Request for Decision

953 Howey Drive, Sudbury

Presented To:	Planning Committee
Presented:	Monday, Jan 25, 2021
Report Date	Thursday, Dec 24, 2020
Type:	Public Hearings
File Number:	751-6/20-19

Staff Report

Photo 3: 953 Howey Drive, Sudbury View of easterly interior side yard File 751-6/20-19 Photography December 10, 2020

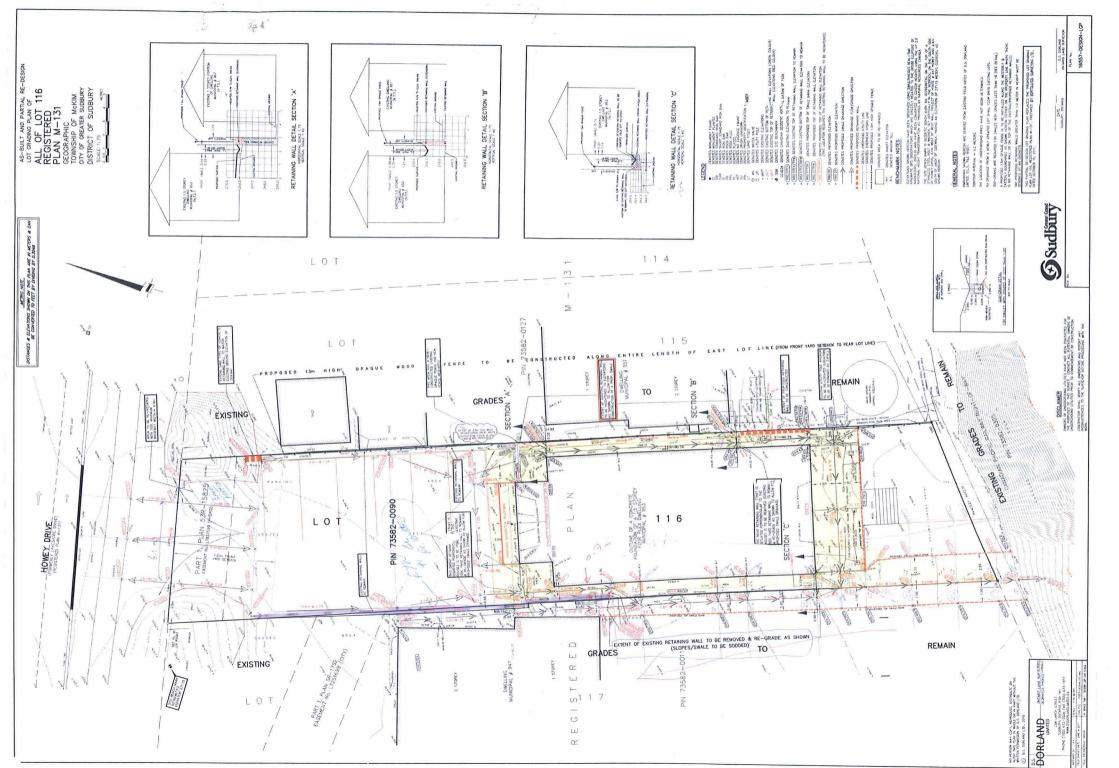
- The lot has insufficient frontage for a multiple dwelling;
- Planting strips cannot be provided due to the narrow width of the lot;
- Parking encroaches into the required front yard in contravention of the Zoning By-law;
- The entire front yard would essentially function as a parking area with little or no landscaping, which is not an acceptable standard for new development;
- The parking area will directly abut the property lines, which presents safety concerns and provides no opportunity to buffer the adjacent dwellings; and,
- There is no room for snow storage.

File 751-6/14-29 953 Howey Drive, Sudbury Floor plan

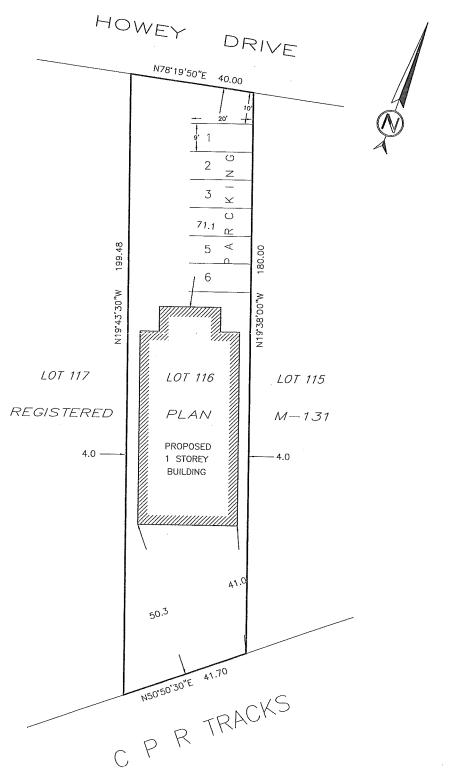
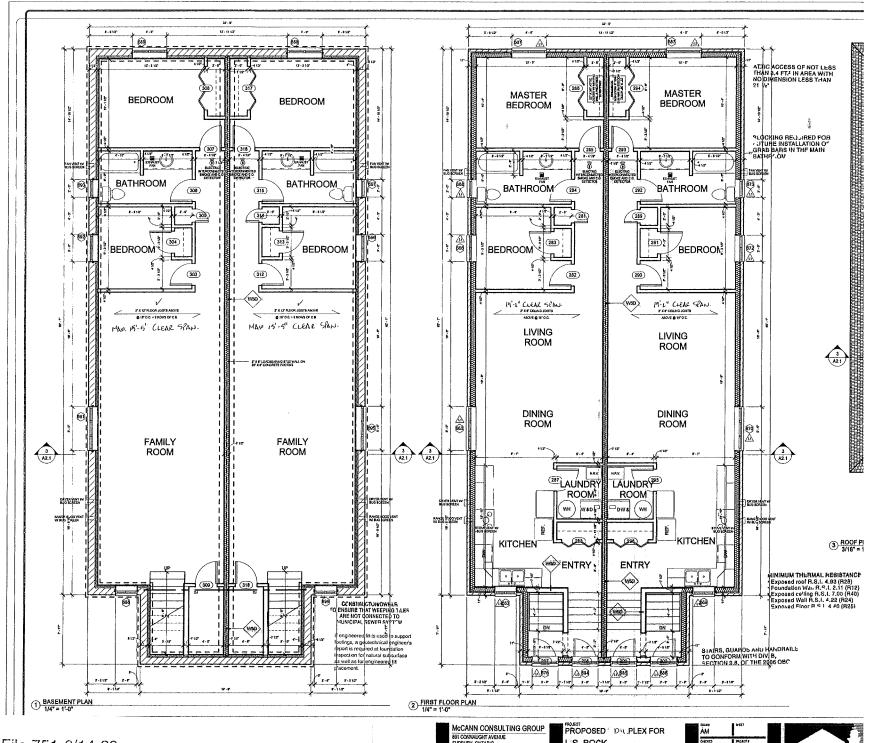
A review of the building permit file and a site visit reveal that the dwelling has been constructed to facilitate conversion to a fourplex. There are four exterior entrances and a layout that it designed to accommodate two (2) more units in the basement (see attached floor plan).
